Transmitted by the chairman of the GFV Group

PROPOSAL FOR A DRAFT SUPPLEMENT TO  
 the 5<sup>th</sup> series of amendments to REGULATION No. 49 (rev.5)

The text reproduced below was prepared by the experts from the informal HDDF Task Force within the GFV informal working group in order to enable the type approval of new EURO V heavy duty dual-fuel engines and vehicles

figure 1: illustration of the HC limits in the case of a Type2B dual-fuel engine operating in dual-fuel mode during the ETC cycle (natural gas dual-fuel engines)

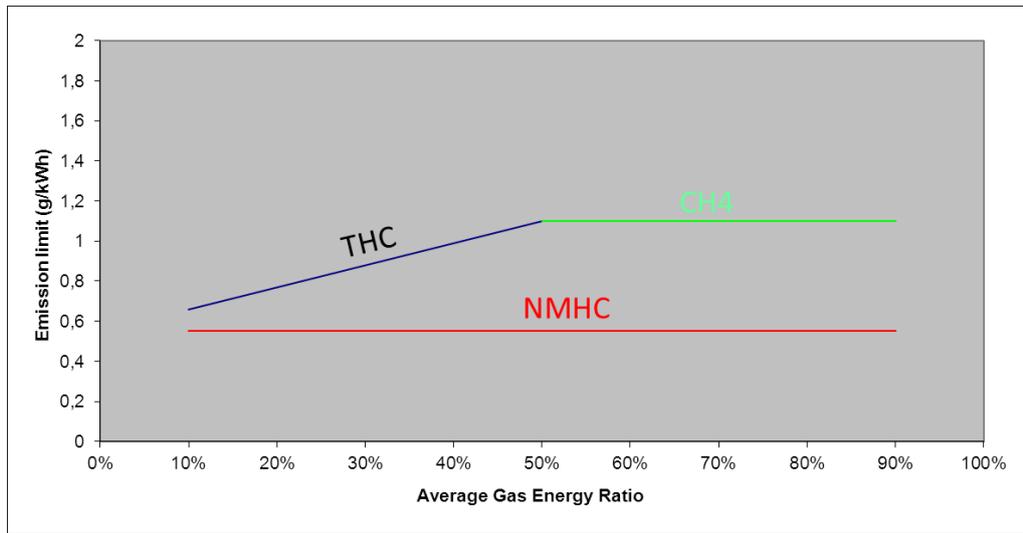
5.2.3. Calculation procedure to determine the hydrocarbon limits (in g/kWh) applicable to Type 2B dual-fuel engines operating in dual-fuel mode during the ETC test cycle.

The following calculation procedure applies to Type 2B dual-fuel engines tested over the ETC cycle while operating in dual-fuel mode :

- Calculate the average gas ratio  $GER_{ETC}$  over the ETC test cycle
- Calculate a corresponding  $THC_{GER}$  in g/kWh using the following formula:  
 $THC_{GER} = NMHC_{NG} + (CH_{4NG} * GER_{ETC})$
- Determine the applicable THC limit in g/kWh using the following method:  
If  $THC_{GER} \leq CH_{4NG}$ , then
  - a) THC limit value =  $THC_{GER}$  and
  - b) No applicable CH<sub>4</sub> and NMHC limit value  
If  $THC_{GER} > CH_{4NG}$ , then
  - a) No applicable THC limit value; and
  - b) Both the  $NMHC_{NG}$  and  $CH_{4NG}$  limit values are applicable.

- $NMHC_{NG}$  is the NMHC emission limit over the ETC test-cycle and made applicable to NG engine in rows B2 and C of table 2 of paragraph 5.2.1 of this Regulation
- $CH_{4NG}$  is the CH<sub>4</sub> emission limit over the ETC test-cycle and applicable to NG engine in rows B2 and C of table 2 of paragraph 5.2.1 of this Regulation
